TOWN OF ADDISON CHANGE ORDER FORM

Change Order Number: 1

Project Name: Addison Airport US Customs and Border Protection Facility

Project Number(s): 19-97

TYPE 3 ACOUSTICAL POCKET DOOR

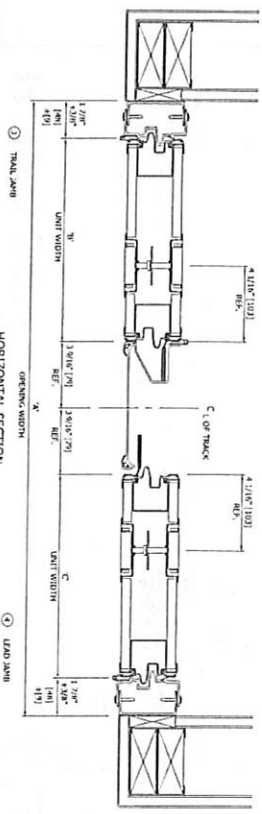
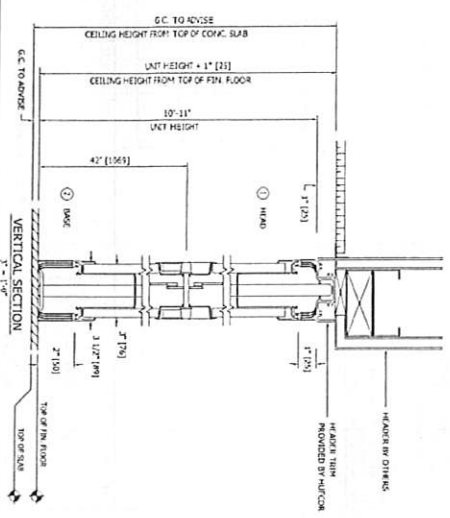
We have downloaded the latest plans, and revised our proposal to INCLUDE a set of Pocket Doors for you (Total Add = \$3,108). This will be the Type 3 set, which allows the panels to seal to the back of the pocket. Please see attached revised shops as well.
